TO: DEVELOPMENT REVIEW BOARD **DATE:** August 21, 2003
FROM: CURRENT PLANNING SERVICES
SUBJECT: CASE 49-DR-2003
REQUEST: Approve site plan & elevations for to construct road-widening improvements
PROJECT NAME: Scottsdale Road Widening / Improvements
LOCATION: Scottsdale Road: Frank Lloyd Wright Blvd To Thompson Peak Pkwy

Stipulations for Case: Scottsdale Road Widening/Improvements 49-DR-2003

ESTHETIC CONCEPTS

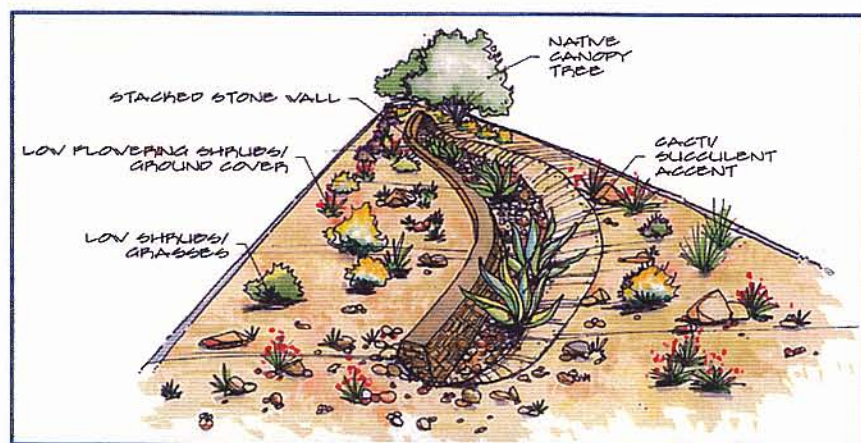
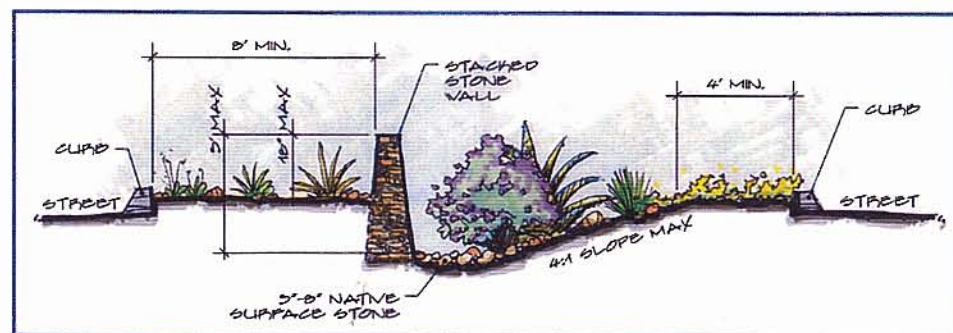
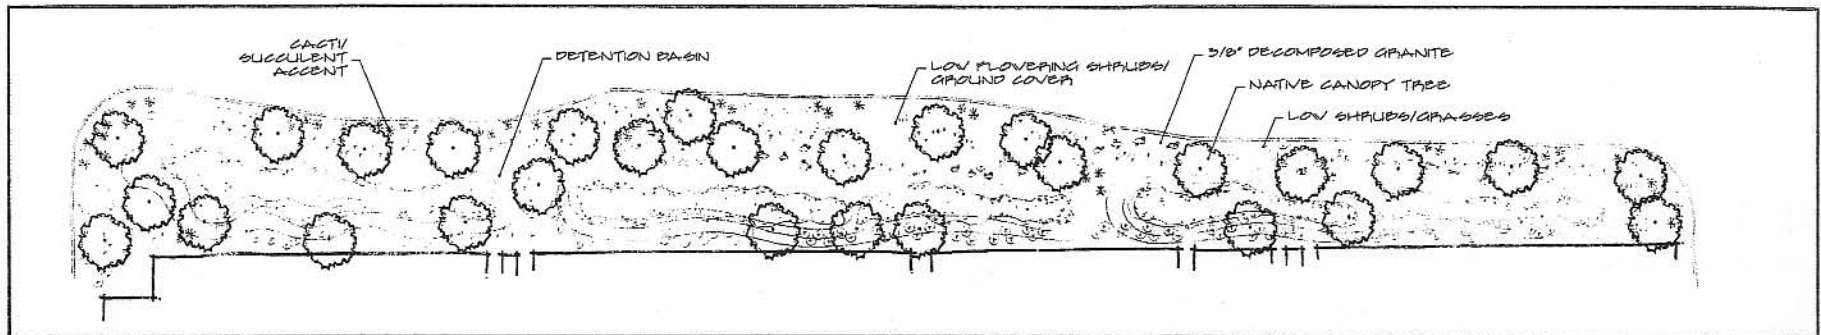
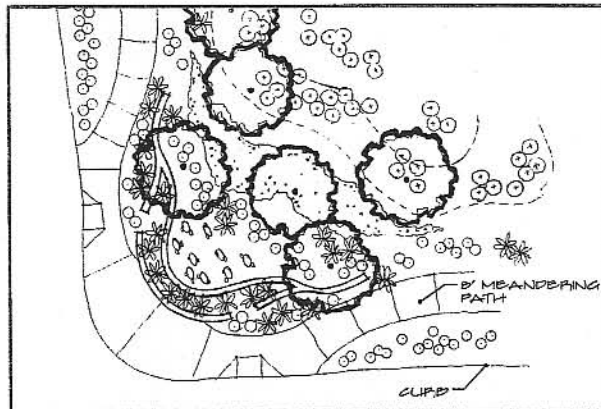
- b. The median(s) configuration of the walls, landscaping, and hardscape be constructed to be consistent with the Aesthetic Concepts plans Page 1 of 2 by Logan Simpson Design, Inc. with a date provided by City of Scottsdale Staff of 6/17/2003.

- c. Landscaping, including location of materials shall be installed to be consistent with the conceptual landscape plan labeled Scottsdale Road (Frank Lloyd Wright to Thompson Peak Parkway) submitted by Logan Simpson Design, Inc. with a date of 6/03

BRIDGE CONCEPT

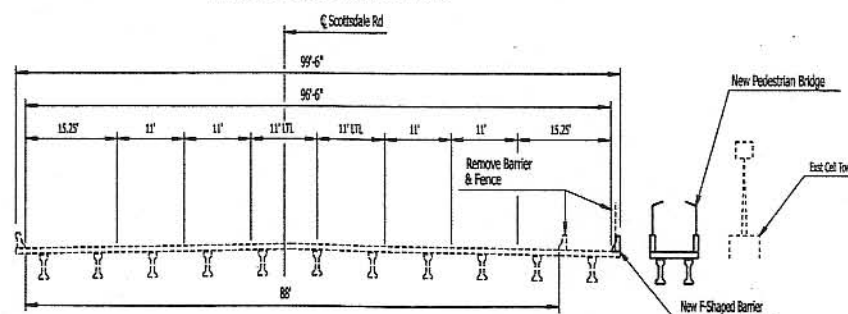
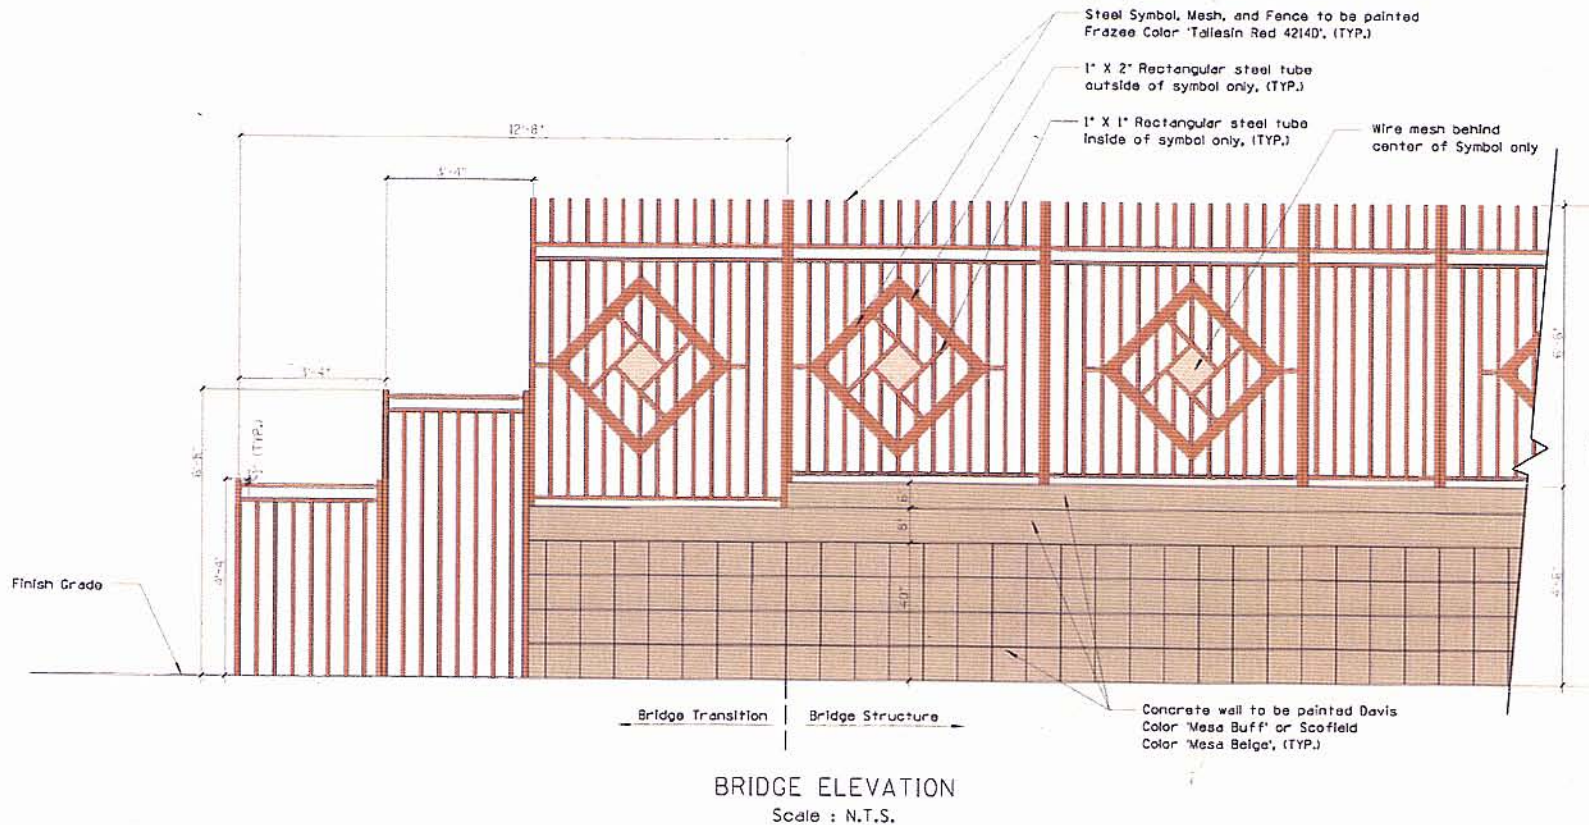
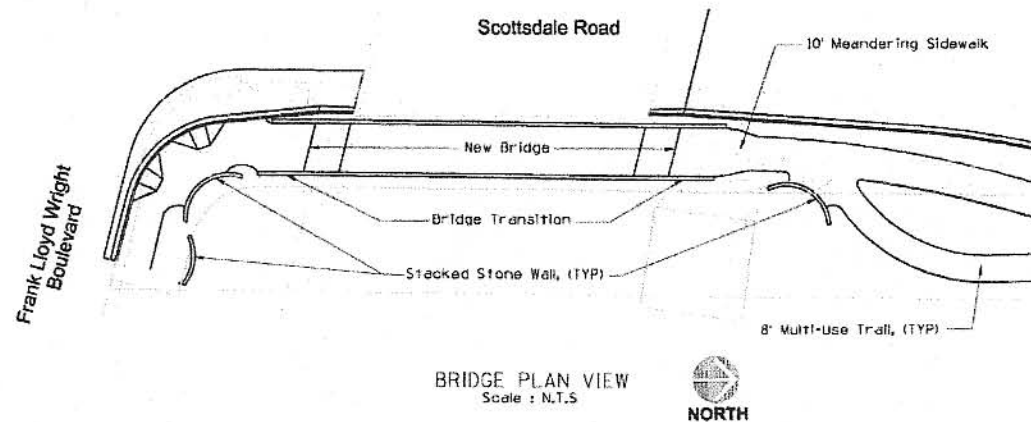
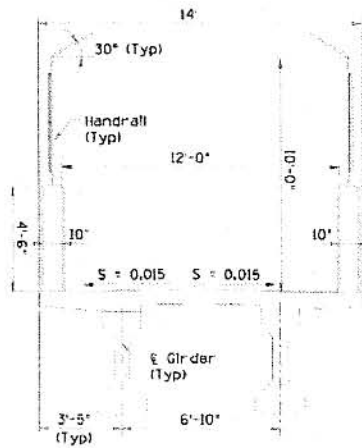
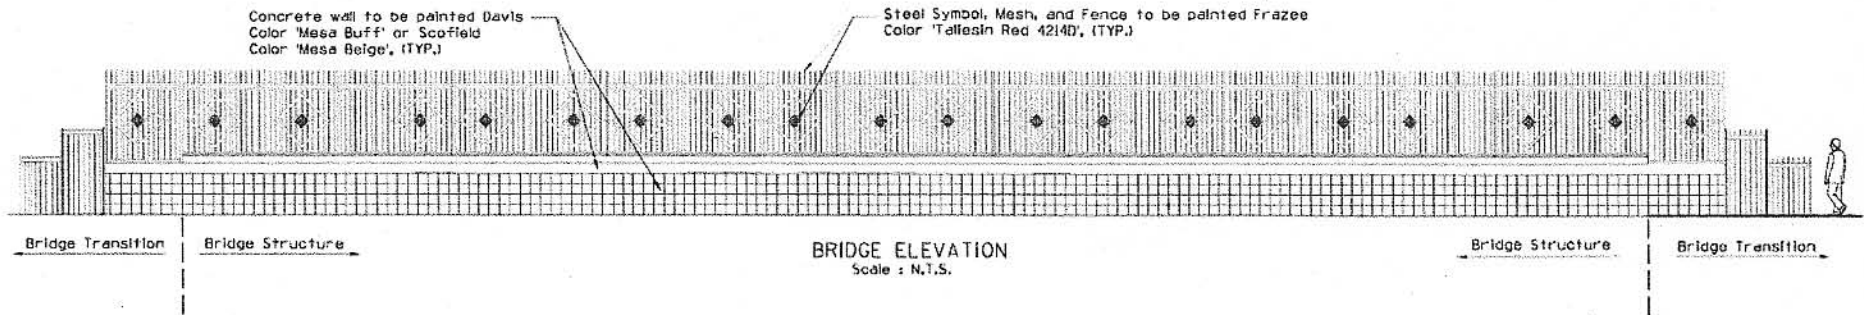
- d. Bridge architectural elements, including dimensions, materials, form, color, and texture, shall be constructed to be consistent plans labeled Bridge Aesthetics plans pages 1 of 2 and 2 of 2 submitted by Dibble & Associates Consulting Engineers with a date provided by City of Scottsdale Staff of 6/17/2003.

WALL TREATMENTS

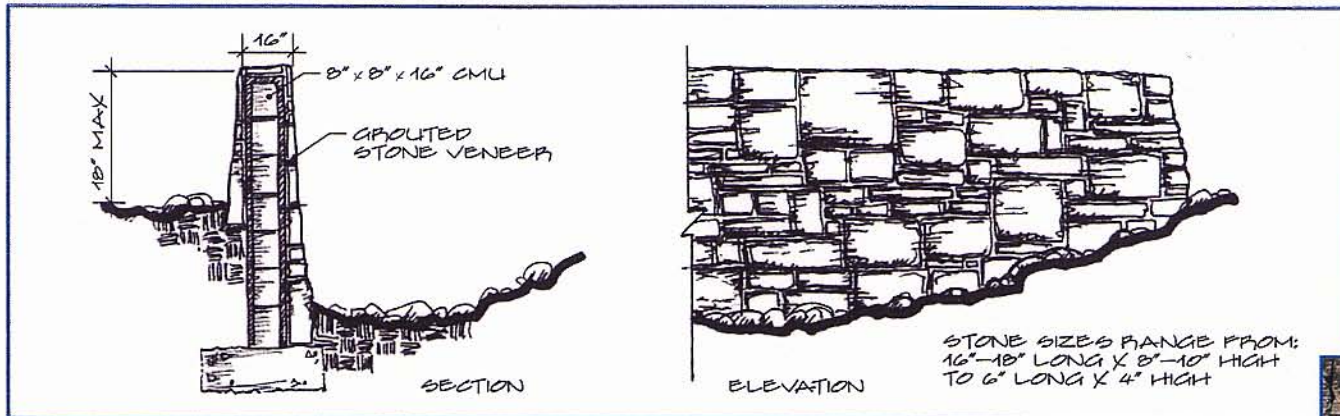
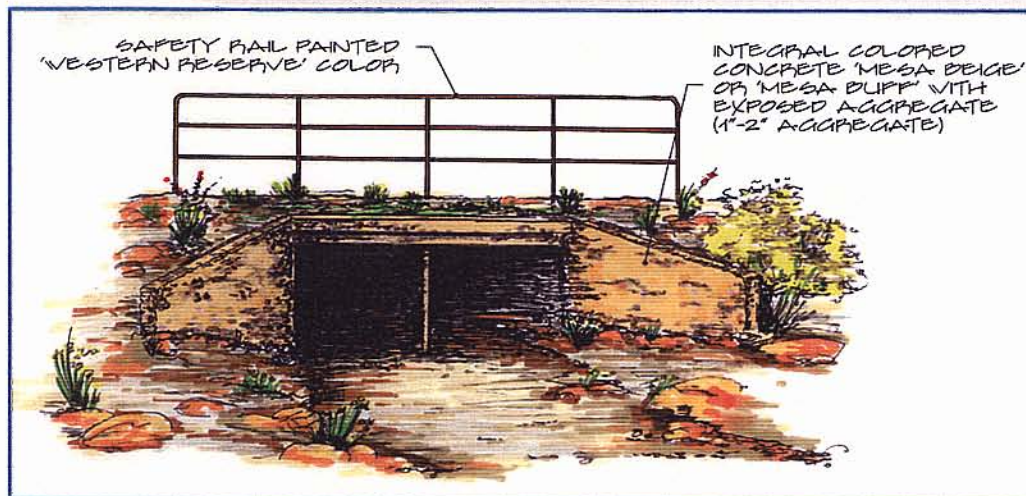
- a. Median(s) architectural wall elements, including dimensions, materials, form, color, and texture, shall be constructed to be consistent plans labeled Wall Alternatives plan and Stone Wall Material Options plan submitted by Logan Simpson Design, Inc. with a date of 6/03.

2. Median wall heights and locations shall conform to the City of Scottsdale's Design Standards and Policy Manual.
